CASE#: C15-2016-0093 LOCATION: 2911 East 3rd Street

## CITY OF AUSTIN APPLICATION TO BOARD OF ADJUSTMENT GENERAL VARIANCE/PARKING VARIANCE

## Master Comment Report

Property: 2911 E 3RD ST

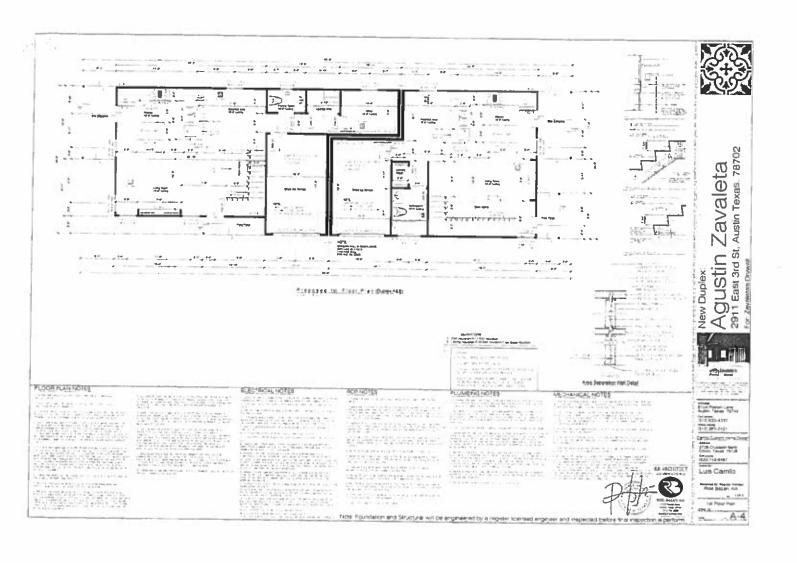
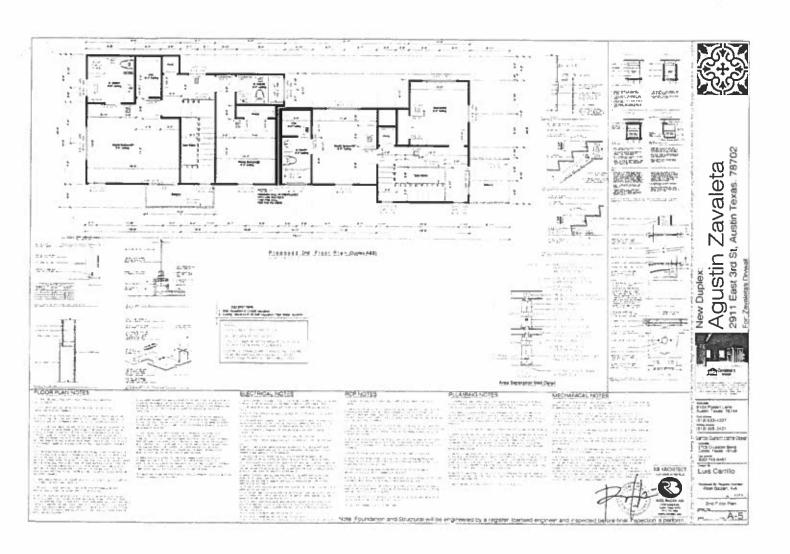
2. Modify sheet A-1 to reflect Type I driveway per Standard 433s-1 or 433s-1A. Submit affected sheet

3. If multiple Type I driveways are proposed, spacing must be provided per TCM 5.3.2. Modify sheet A.1 accordingly and submit affected sheet with update.

4. Compliance with sidewalk ordinance required. Show COA sidewalk along one of the two street frontages per Standard 432s-1 on sheet A-1 or contact Amber Mitchell in Development Assistance Center to request fee in lieu payment. If fee in lieu is chosen, provide approval memo from Amber and receipt of payment with update. Submit affected sheet with update.

- 1. Comment Noted.
- Please refer to the revised plans reflecting the changes and details to accommodate this requirement.
- Please refer to the revised drawings reflecting one driveway to accommodate both units providing access to each garage.
- 4. I will get with Amber Mitchell in regards to being compliance with the requirements of the sidewalks.
- 5. Please see attach drawings showing the line of intersection of the tents.
- Please see attached revised drawings reflecting the changes on pulling the building line front the face façade.

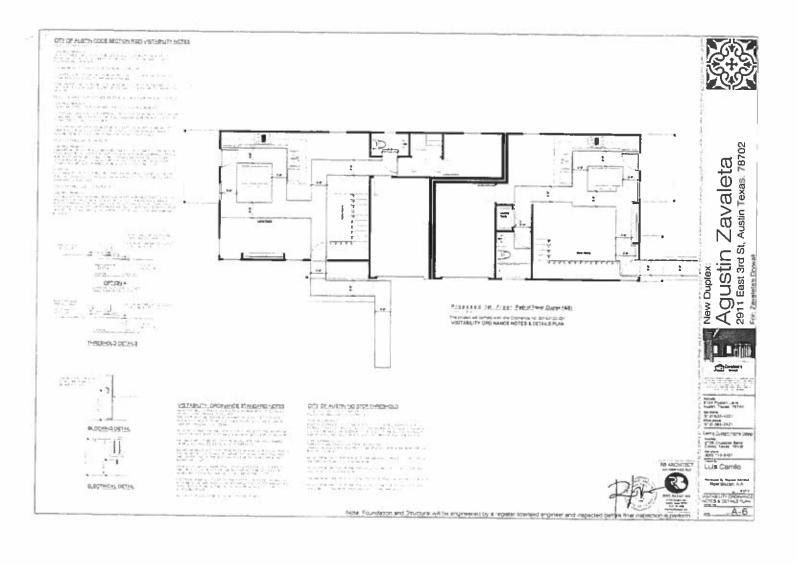
5. Label length of tent encroachment and line of intersection on west elevation (sheet A-2) and reference applicable tent exception by note as per 25-2 Subchapter F Art. 2.6.E. Submit affected sheet with update.
